RIDGWAY PLANNING COMMISSION

AGENDA

Tuesday, September 25th, 2018
Regular Meeting; 5:30 pm
Ridgway Community Center
201 North Railroad Street, Ridgway, Colorado

Subject: Preliminary Plat Submittal
Legal: Ridgway Land Company Subdivision Lots 30-34
Address: TBD Redcliff Drive
Parcel #s: 430516402012, 430516402011, 430516402010, 430516402009, 430516402008
Zone: General Commercial
Applicant: Joseph Nelson
Owners: Ridgway Land Co. / Rob Hunter
Initiated By: Shay Coburn, Planner
Date: September 25, 2018

1 SITE DEVELOPMENT PLAN - LOT 18
SCALE: 1/8" = 1'-0" 7,455 S.F. NORTH

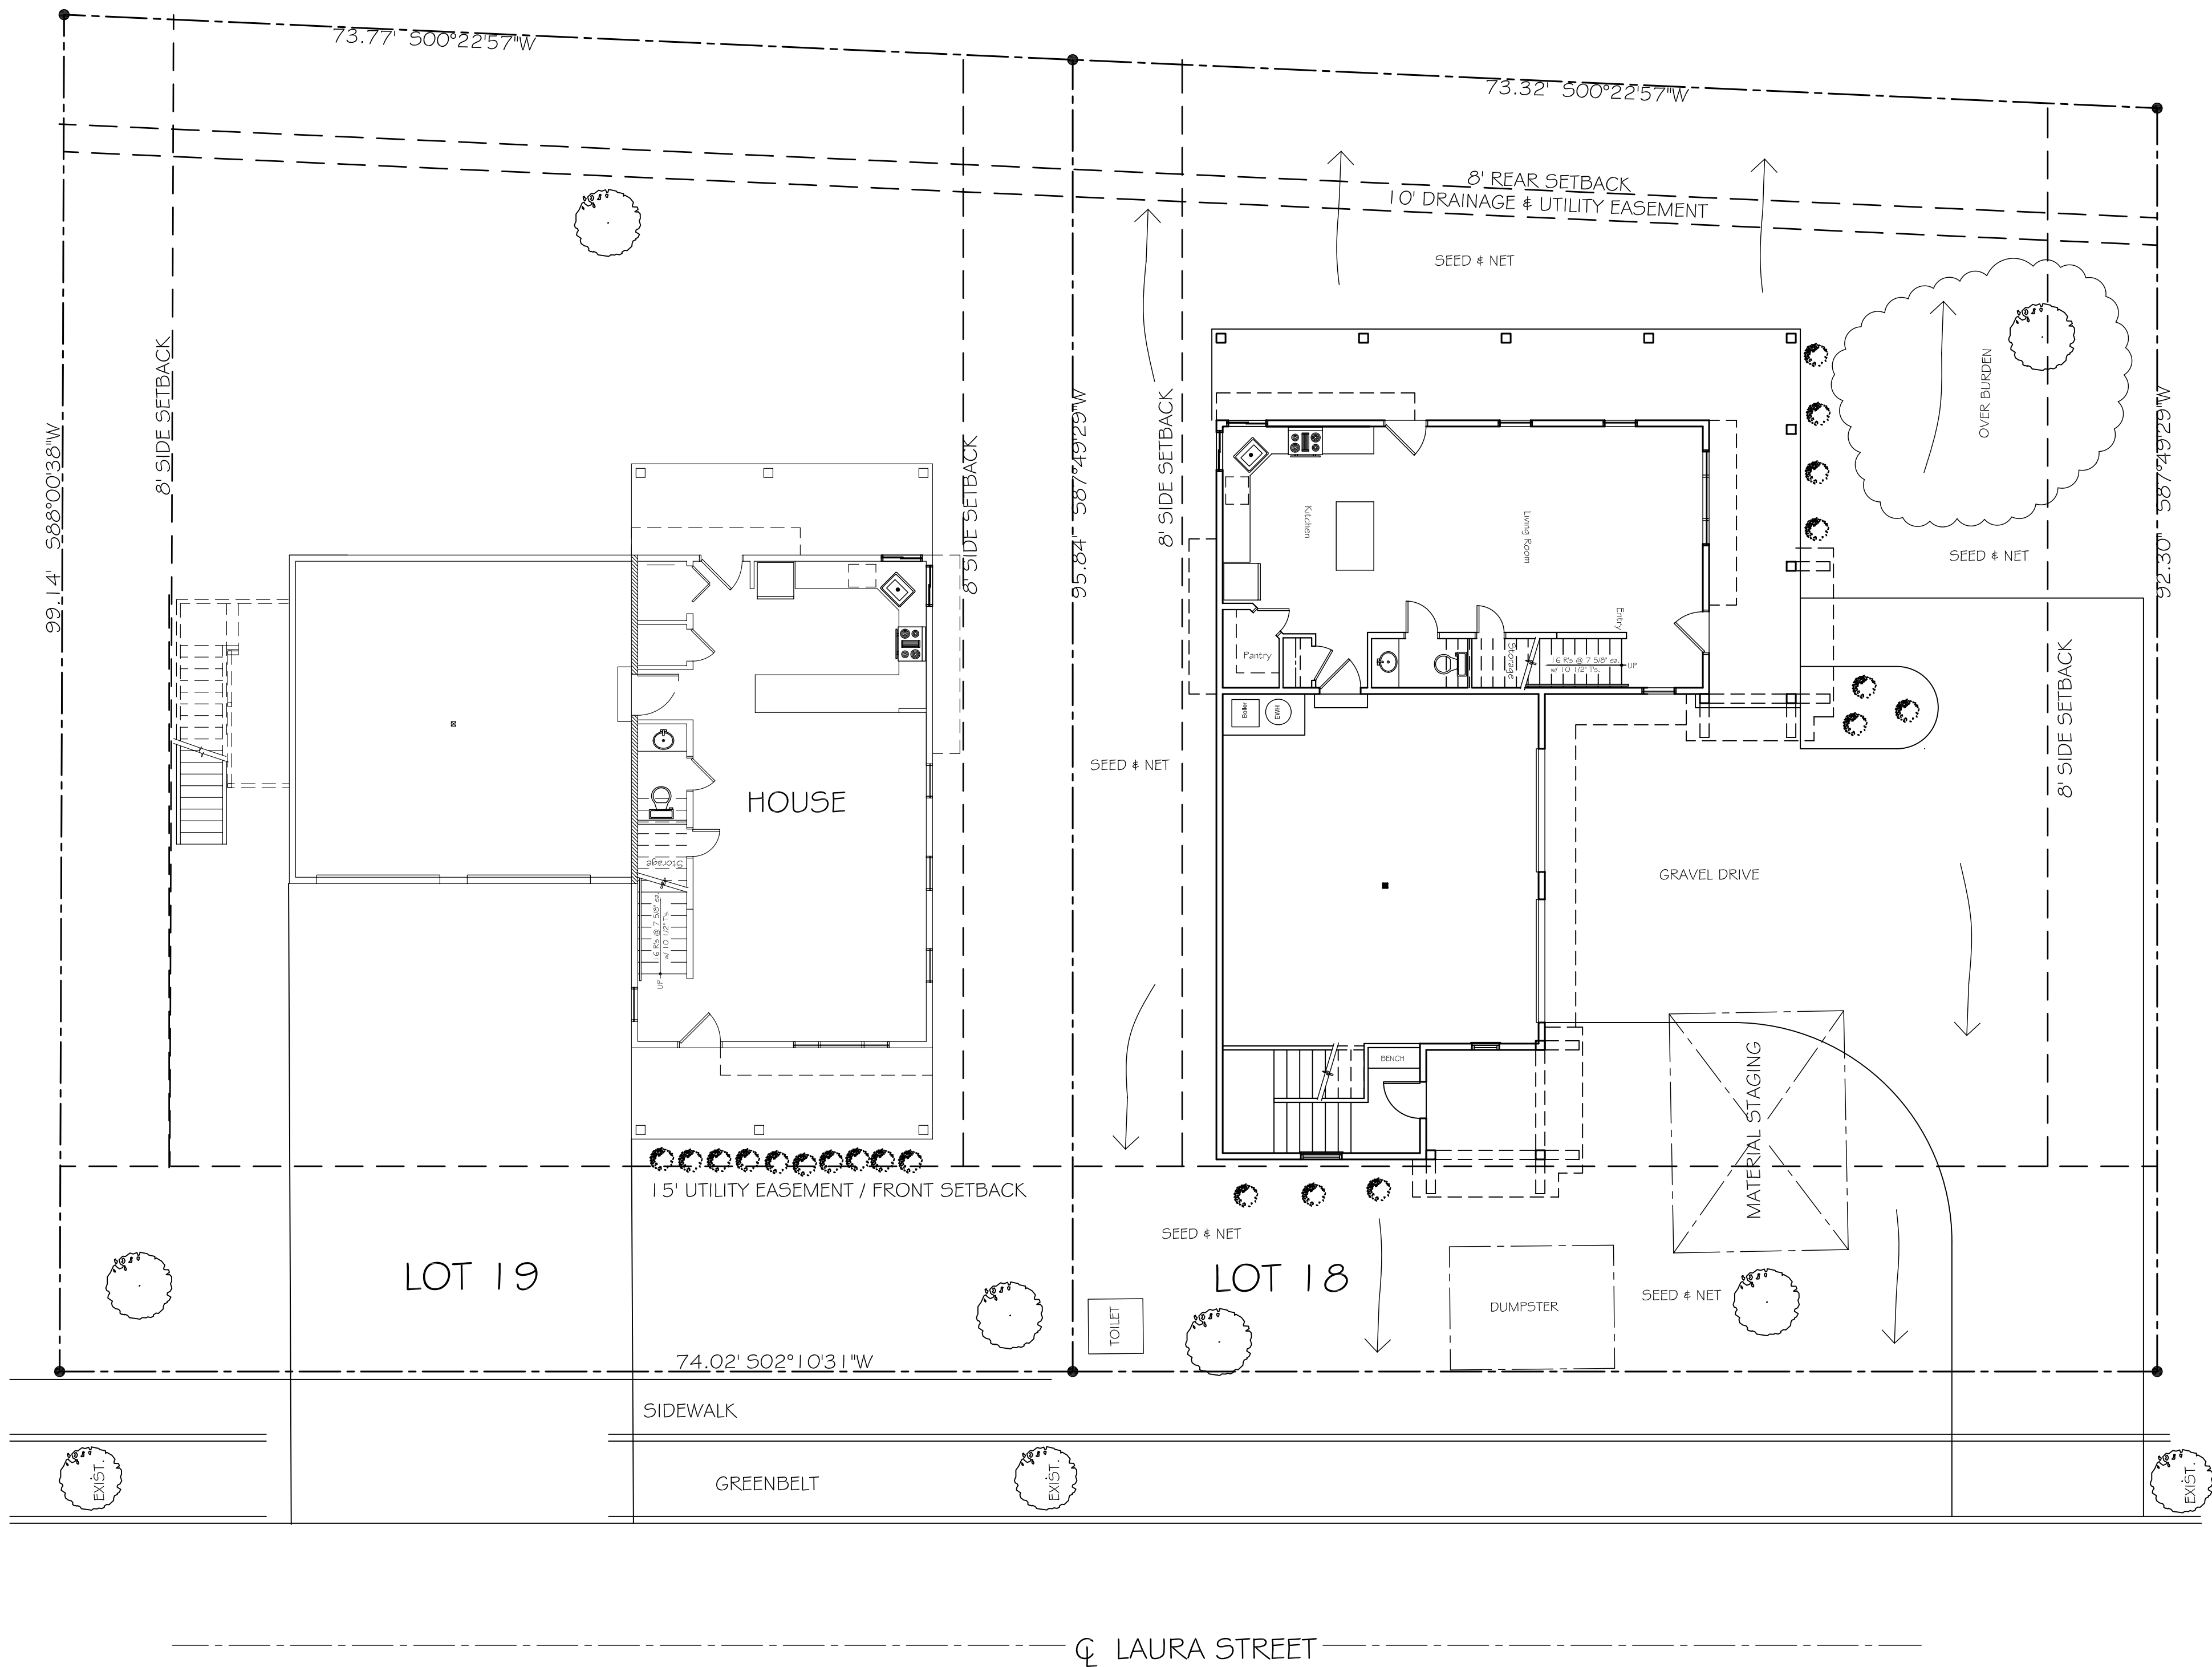
I am requesting a deviation from the Single-Family Design Guidelines for a house that I am building in Parkside. As designed the house is one to narrow to meet the guidelines.

The main compensating feature that meets the intent of the guidelines is the attached garage. The way the garage sits perpendicular to the main house give the appearance the house footprint is much larger.

There are 16 other home within ¼ mile of this home that has the same size foot print. All the affordable house in River Park use this same floor plan. Therefore, the house is compatible with the other houses and fits harmoniously into the community.
